Three Mile Island, Unit 1 (TMI Unit 1)  
Facility Operating License No. DPR-50  
NRC Docket No. 50-289

Subject: Response To Request For Additional Information –  
Technical Specification Change Request No. 326: Elimination of Containment  
Equipment Hatch Closure During Refueling (TAC No. MC4904)

**RESPONSE TO REQUEST FOR ADDITIONAL INFORMATION  
TECHNICAL SPECIFICATION CHANGE REQUEST No. 326  
ELIMINATION OF CONTAINMENT EQUIPMENT HATCH  
CLOSURE DURING REFUELING**

FIG. NO. CMR-93-0029-153-01

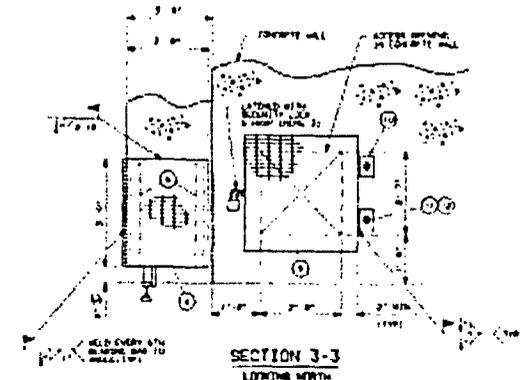
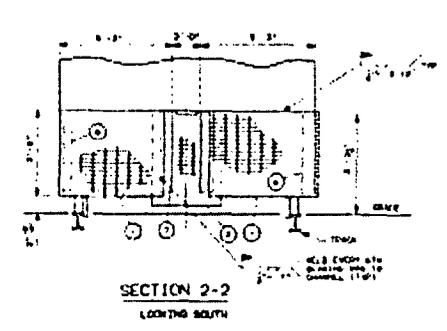
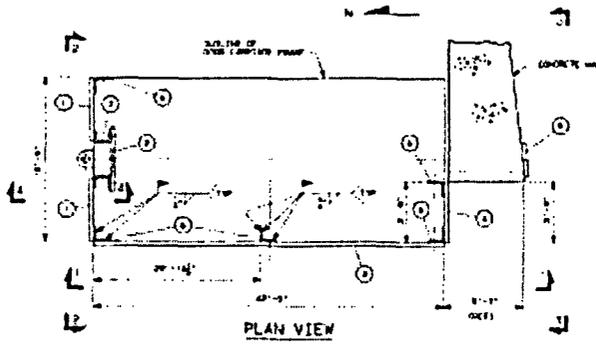
Please provide engineering drawings of the proposed change. A photograph of the equipment hatch would also be helpful in the review of this proposed change. Describe the steps taken to ensure any proposed flashing will not interfere with closure of the Equipment Hatch opening. What is the acceptable design clearance between any proposed flashing on the shield doors and the containment to ensure that the flow after the opening is closed is into containment?

Photographs and drawings of the TMI Unit 1 equipment hatch missile shield barrier are attached. The proposed change permanently adds steel plate to the lower most missile shield carriage area. The added steel plate will cover the area where grating is currently installed. The added steel plate will not create an interference fit, which would interfere with equipment hatch missile shield closure. The equipment hatch missile shield has a 2-inch clearance above the existing asphalt grade. A 3-inch clearance along the vertical face of the missile shield exists at its interface with the extended concrete impact enclosure, which extends from containment. The total area of these clearances with the Reactor Building Purge Exhaust System operating and the missile shield installed, ensure that flow is into the Reactor Building.
